ADDENDUM NUMBER 1 TO THE BID DOCUMENTS

Amendment Date: **May 3, 2021**

**BID DOCUMENT NUMBER 2021-01
HORIZON SEWER PROJECT**

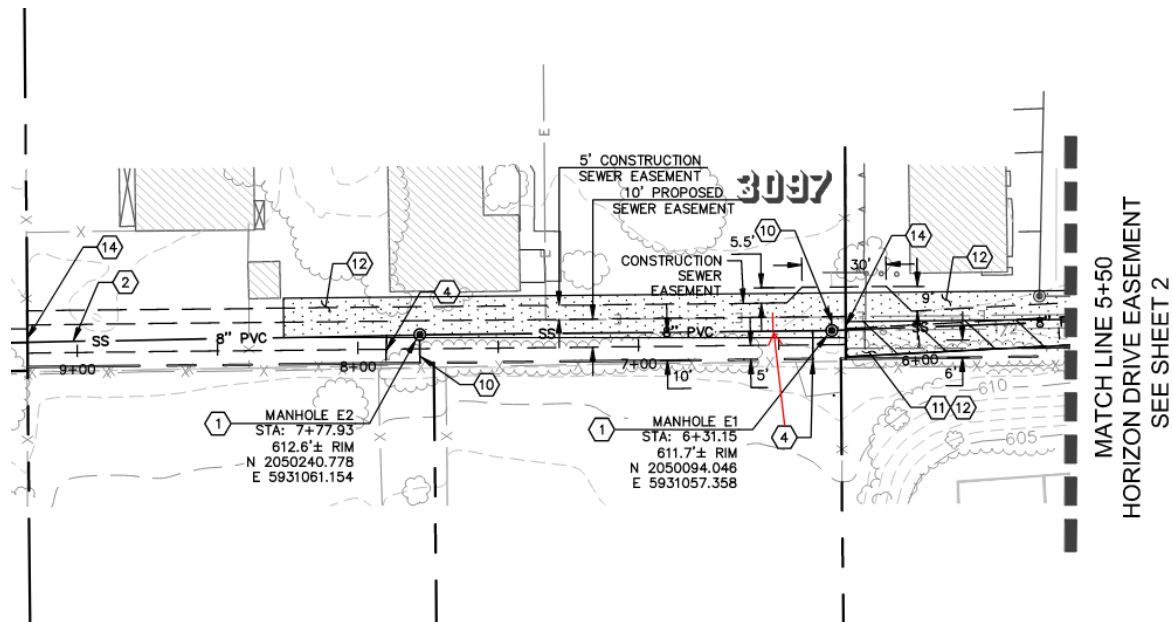
16. Question: Bid Item #8 I count 20 Laterals the bid schedule shows 21 ea.

Answer: The bid schedule is correct. Please provide 21 sewer laterals. A lateral for 3097 Hwy 246 was not shown on the plans. See below for approximate location.

CHIMNEY AND DEEP LATERAL

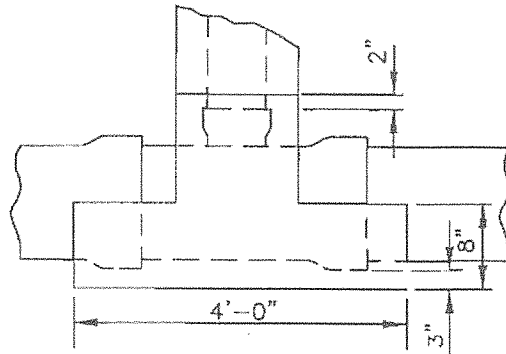
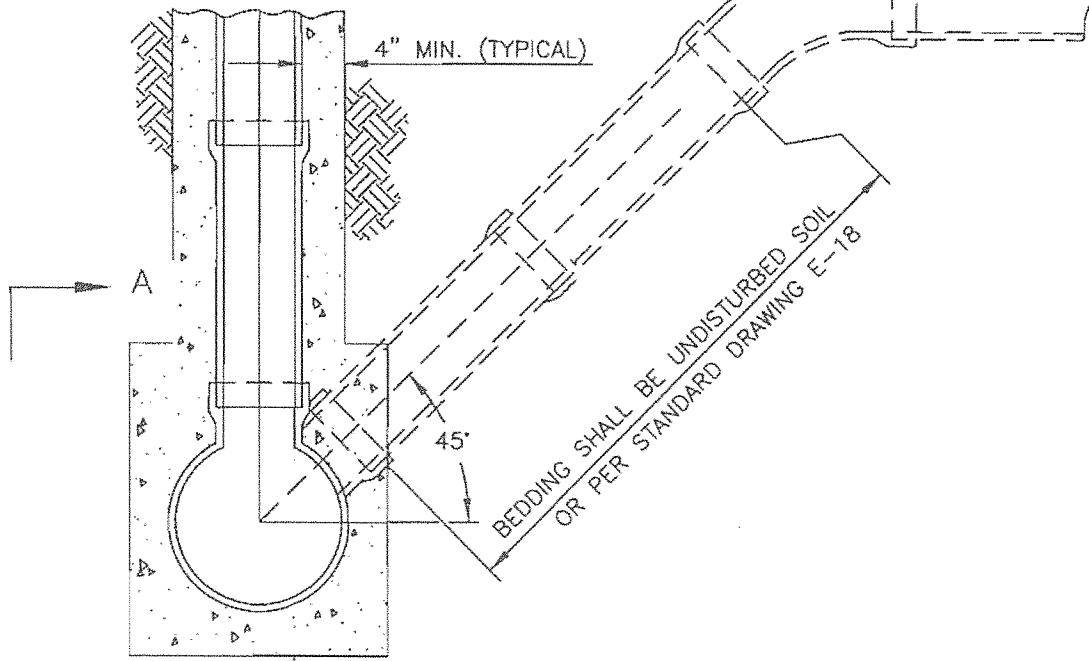
Question #02	
Subject:	Lateral Connections to Mainline
Reference Specification:	
Reference Plan Page:	
Question:	Several laterals are called out to be installed to the mainline throughout the project alignment. Typical Lateral Sewer Detail S-3 shows the lateral branch wye coming off the mainline, and Lateral Sewer Installation Detail S-6 shows installation from the mainline to the property with via 3-options: 1) Standard Lateral Sewer, Alternate "A", or Alternate "B". Question: Due to the significant depth of the mainline sewer, would the District allow a concrete encased "Chimney" style lateral connection per the attached detail?

Answer: Yes, a "chimney" style lateral is acceptable for deep laterals. Attached sample detail would be acceptable.
